| Title | | OVP Circuit | |
| Size | Document Number | 501-1-01039 | Rev |

LNK306

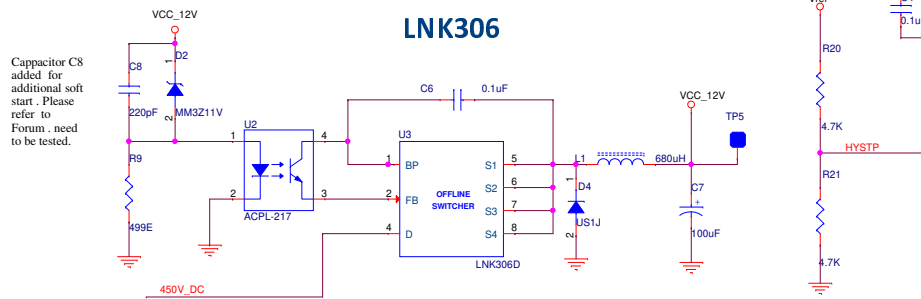
Capacitor C8 added for additional soft start. Please refer to Forum, need to be tested.
